# U.S. Department of the Interior BUREAU OF LAND MANAGEMENT

Well Name: SHANGHAI ROOSTER 15- Well Location: T25S / R29E / SEC 15 / County or Parish/State: EDDY /

**Sundry ID:** 2701767

Type of Action: APD Change

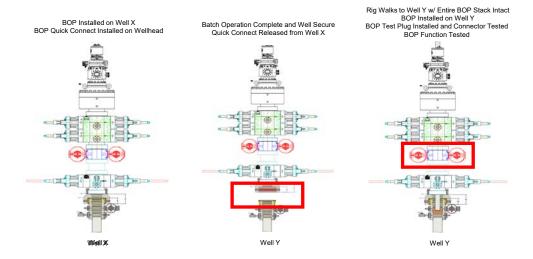
XTO Energy requests a variance to ONLY test broken pressure seals on the BOPE and function test BOP when skidding a drilling rig between multiple wells on a pad.

XTO Energy feels break testing and our current procedures meet the intent of OOGO No. 2 and often exceed it. There has been no evidence that break testing results in more components failing than seen on full BOP tests. XTO Energy's internal standards requires complete BOPE tests more often than that of OOGO No. 2 (Every 21 days). In addition to function testing the annular, pipe rams and blind rams after each BOP nipple up, XTO Energy performs a choke drill with the rig crew prior to drilling out every casing shoe. This is additional training for the rig crew that exceeds the requirements of the OOGO No. 2.

Note: Picture below highlights BOP components that will be tested during batch operations

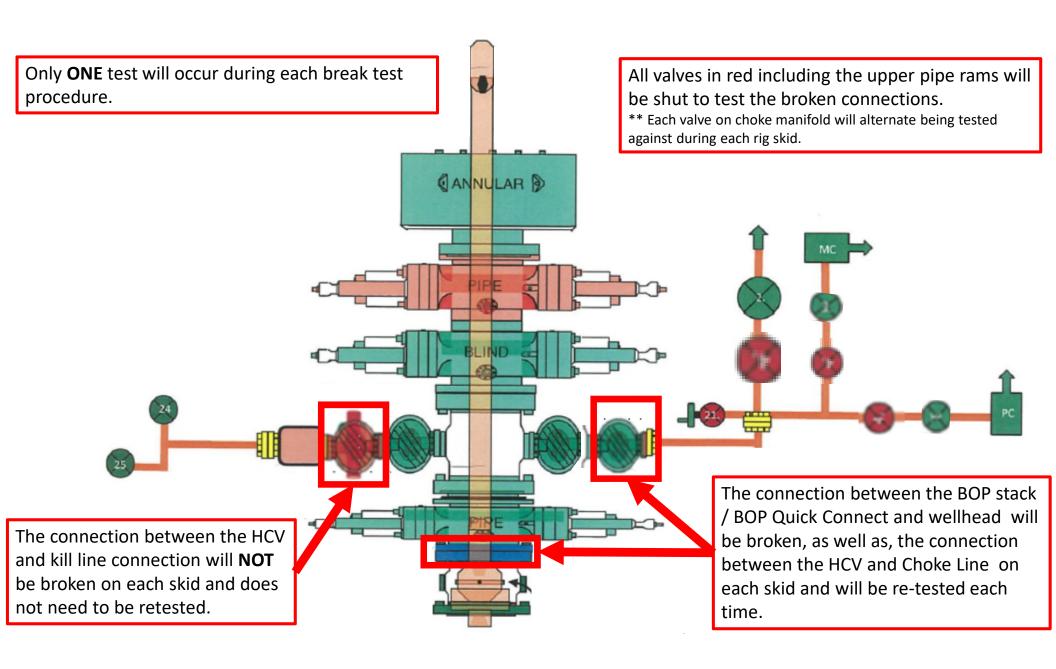
- 3. After performing a complete BOP test on the first well, the intermediate hole section will be drilled and cased, two breaks would be made on the BOP equipment.

- a. Between the HCV valve and choke line connection
  - b. Between the BOP guick connect and the wellhead
- 4. The BOP is then lifted and removed from the wellhead by a hydraulic system.

- 5. After skidding to the next well, the BOP is moved to the wellhead by the same hydraulic system and installed.
- 6. The connections mentioned in 3a and 3b will then be reconnected.

- 7. Install test plug into the wellhead using test joint or drill pipe.
- 8. A shell test is performed against the upper pipe rams testing the two breaks.

Based on discussions with the BLM on February 27th 2020 and the supporting documentation submitted to the BLM, we will request permission to ONLY retest broken pressure seals if the following conditions are met:

- 1. After a full BOP test is conducted on the first well on the pad.
- 2. The first intermediate hole section drilled on the pad will be the deepest. All of the remaining hole sections will be the same depth or shallower.
- 3. Full BOP test will be required if the intermediate hole section being drilled has a MASP over 5M.
- 4. Full BOP test will be required prior to drilling the production hole.

Wellhead diagram during skidding operations

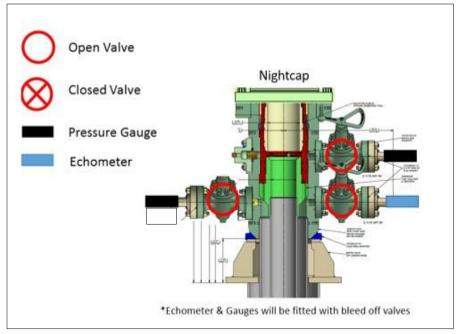
- 6. Skid rig to next well on pad.
- 7. Confirm well is static before removing cap flange, flange will not be removed and offline cementing operations will not commence until well is under control. If well is not static, casing outlet valves will provide access to both the casing ID and annulus. Rig or third party pump truck will kill well prior to cementing or nippling up for further remediation.

Wellhead diagram during offline cementing operations

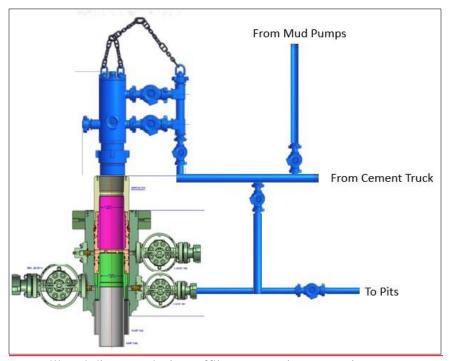
- 10. Circulate bottoms up with cement truck
  - a. If gas is present on bottoms up, well will be shut in and returns rerouted through gas buster to handle entrained gas
  - b. Max anticipated time before circulating with cement truck is 6 hrs
- 11. Perform cement job taking returns from the annulus wellhead valve
- 12. Confirm well is static and floats are holding after cement job
- 13. Remove cement equipment, offline cement tools and install night cap with pressure gauge for monitoring.
